2.4 Hydrology

2.4.1 Hydrologic Description

2.4.1.1 Technical Information in the Application

Figure 2.4-4 Small drainage basins (Basins A and B) that are drained by small, steep streams to the north and south of the GGNS site

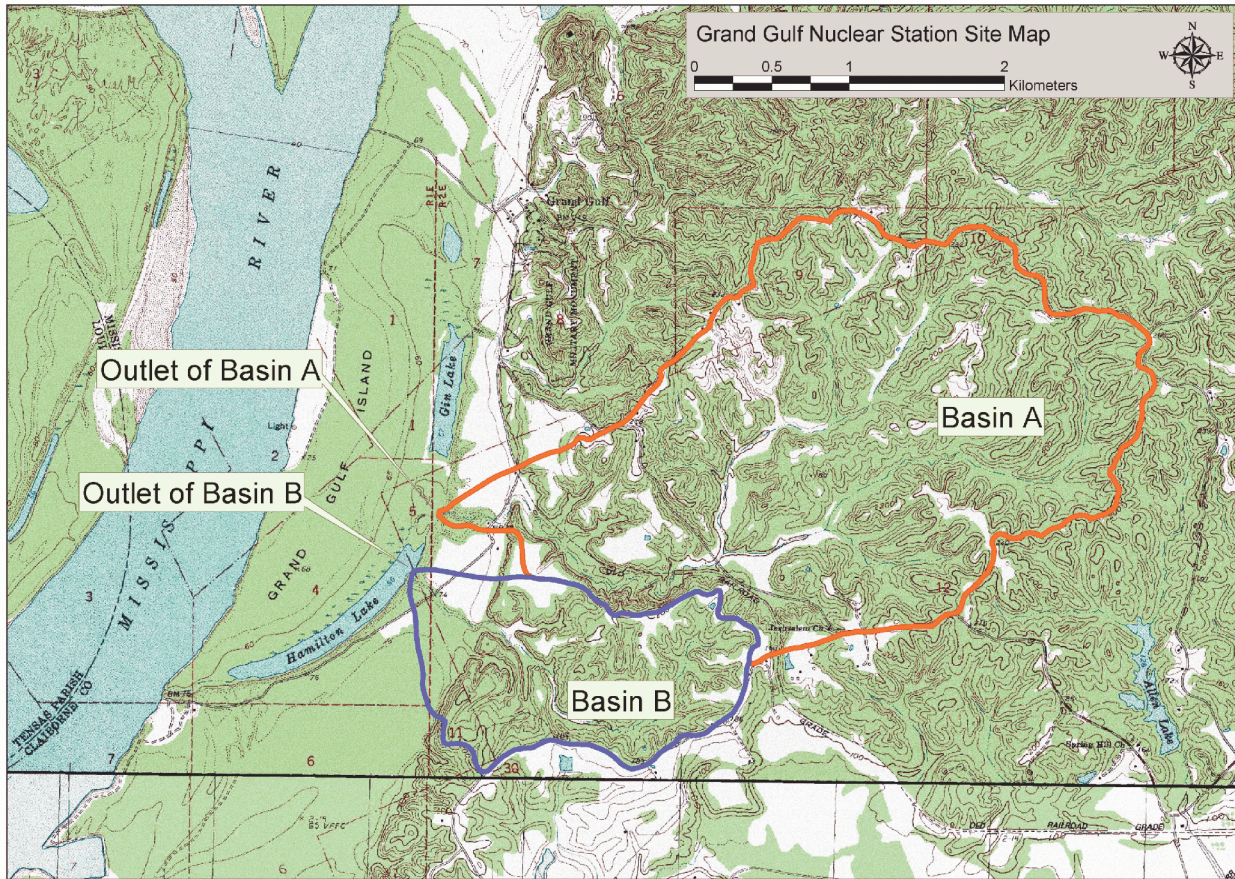
The staff independently verified the applicant's description of the two small, steep streams that flow around the GGNS site. The staff manually delineated the watersheds for these two streams using USGS topographic maps (Figure 2.4-4). Stream A, located to the north of the GGNS site, drains Basin A. The staff estimated that the contributing area of Basin A at its outlet into Hamilton Lake is approximately 2.94 mi². Stream B, located to the south of the GGNS site, drains Basin B. The staff estimated that the contributing area of Basin B at its outlet into Hamilton Lake is approximately 0.68 mi².

Figure 2.4-5 Grand Gulf ESP site vicinity map

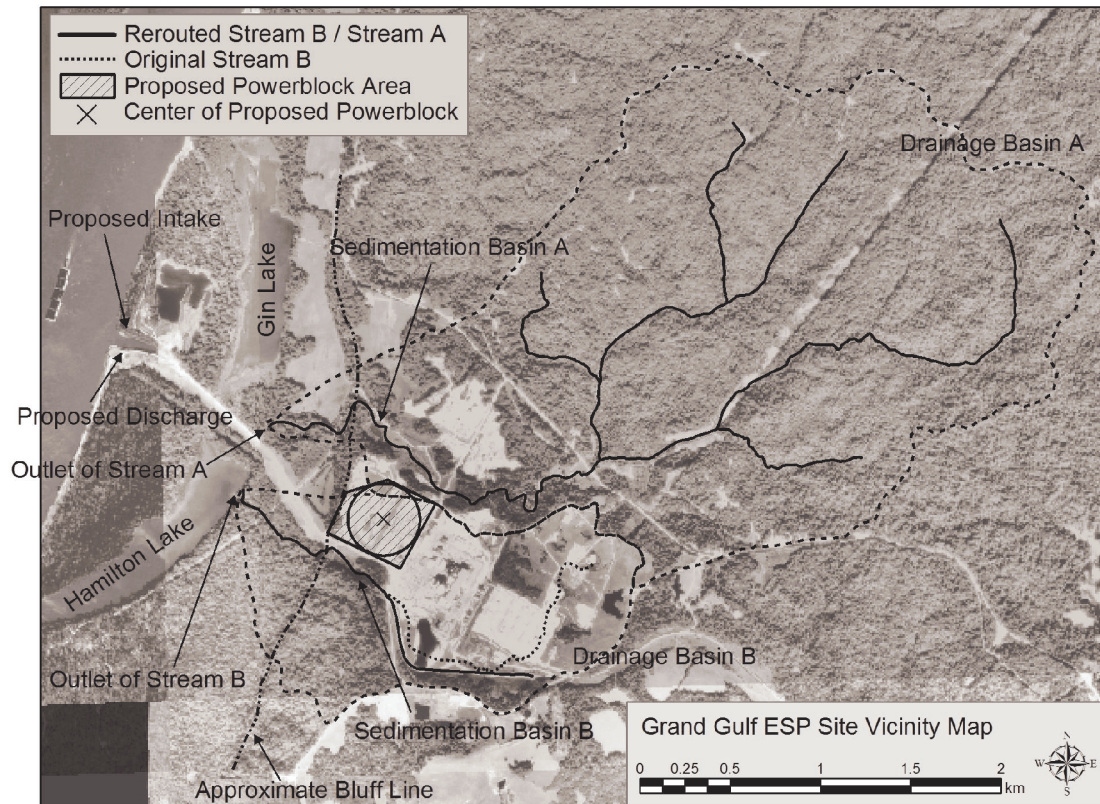
The staff's review of SSAR Figures 2.1-1 and 2.1-2 revealed that, although the coordinates inscribed on these figures for the center of the proposed powerblock are the same as those mentioned in applicant's response to RAI 2.4.1-1, the coordinates do not agree accurately with the position of the center of the proposed powerblock as drawn on these figures. The staff independently created a map to more accurately locate the center of the proposed powerblock. Figure 2.4-5 shows this map.

The map shown in Figure 2.4-5 uses the UTM Zone 15N North American Datum (NAD) 1983 geographic projection. As shown on SSAR Figures 2.1-1 and 2.1-2, the applicant's PPBA is located north of the heavy haul road, east of the bluffs, and southeast of the ESC building. The staff created the polygon labeled "Proposed Powerblock Area" on Figure 2.4-5 closely following the location of applicant's PPBA shown on SSAR Figures 2.1-1 and 2.1-2. The staff overlaid the largest circle that could fit inside the PPBA as shown in Figure 2.4-5. The staff assumed that the center of this circle represents the location of the center of the proposed powerblock. The UTM coordinates determined by the staff for the center of the proposed powerblock are N3,543,266.06 meters and E684,017.28 meters, with reference to the UTM Zone 15N NAD 1983 geographic projection.

The staff also overlaid the applicant-stated coordinates of the center of the proposed powerblock on the map and found that these coordinates place the proposed powerblock approximately 302 feet southwest of the staff-estimated coordinates mentioned above and closer to Stream B. Because of this discrepancy between the coordinates provided by the applicant and the plotted location of the powerblock on Figures 2.1-1 and 2.1-2, the staff cannot determine the actual location of the powerblock on the ESP site. Therefore, the staff required additional information on the true coordinates of the center of the powerblock. This was

Open Item 2.4-1. The staff intended to specify the coordinates of the center of the proposed powerblock as a permit condition subsequent to the satisfactory resolution of Open Item 2.4-1.

In response to Open Item 2.4-1 (Response to Request for Additional Information to Resolve the Grand Gulf Early Site Permit draft Safety Evaluation Report Open Items, System Energy Resources, Inc., June 21, 2005), the applicant stated that the UTM coordinates indicated in the SSAR, ER, and Environmental Policy Institute documents were inaccurate because of an error in a spreadsheet which was used to calculate UTM coordinates corresponding to Mississippi West grid coordinates. The applicant converted the coordinates of the center of the ESP powerblock, N550,099 feet and E277,346 feet in the Mississippi West grid coordinate system, to N3,543,261 meters and E684,018 meters in the UTM Zone 18 NAD 83 projection system using USACE software Corpscon Version 6.0. The applicant revised Figures 2.1-1, 2.1-2, 2.2-4, 2.4-1, 2.4-10, and 2.4-33 of the SSAR. The applicant also revised SSAR Sections 1.2, 2.1.1.1, and 2.4.1.1; Part 1, "Administrative Information," in Section 1.1; Part 4, "Emergency Planning Information," and Figures 2-1 and 2-3; and Section 2.1.1, ER Figures 2.1-1, 2.2-1, 2.3-1, 2.3-7, 2.3-12, and 2.3-20; and ER Sections 1.1, 2.1, 2.3, and 4.5.1 to include corrected UTM coordinates.

The staff reviewed the applicant's response to Open Item 2.4-1 and concluded that the corrected UTM coordinates of the center of the proposed ESP powerblock are approximately 16.8 feet away from the coordinates estimated by the staff in its independent review. Since this

Figure 2.4-8 Simplified cross-section of the Mississippi River near the ESP site (not drawn to scale)

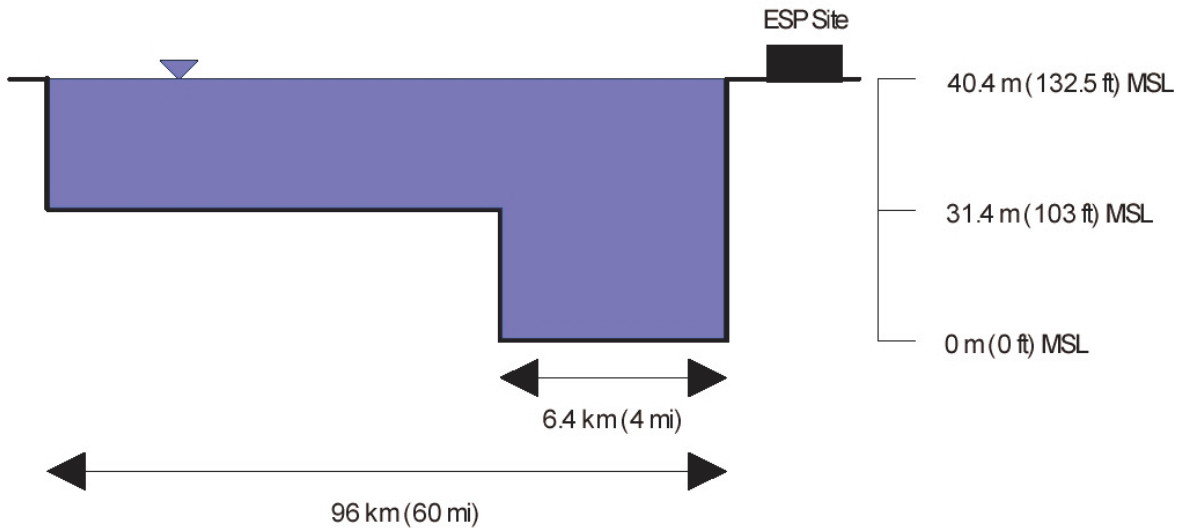
The staff carried out a simplified bracketing estimation of the discharge needed to raise the water surface elevation near the GGNS site above the existing GGNS Unit 1 plant grade of 132.5 feet above MSL. The staff assumed a simplified cross-section for the Mississippi River near the GGNS site, as shown in Figure 2.4-8. The staff conservatively assumed that the width of the floodplain is 60 miles, even at a water surface elevation of 132.5 feet above MSL. The cross-sectional area of discharge is estimated as 11.5 million square feet (ft²). The wetted perimeter was estimated as 317,065 feet.

Based on a staff-assumed Manning's roughness coefficient of 0.025 for natural channels and a bed slope of 0.2 feet per mile (ft/mi), the staff estimated the discharge in the Mississippi River corresponding to a water surface elevation of 132.5 feet above MSL as 46.3 million cfs. This estimate is more than four times larger than the discharge capacity of the river at a water surface elevation of 103 feet above MSL, and about seven times larger than the applicant-estimated PMF. Therefore, the staff concluded that the ESP site is safe from flooding caused by a seismically induced dam failure upstream of the GGNS site.
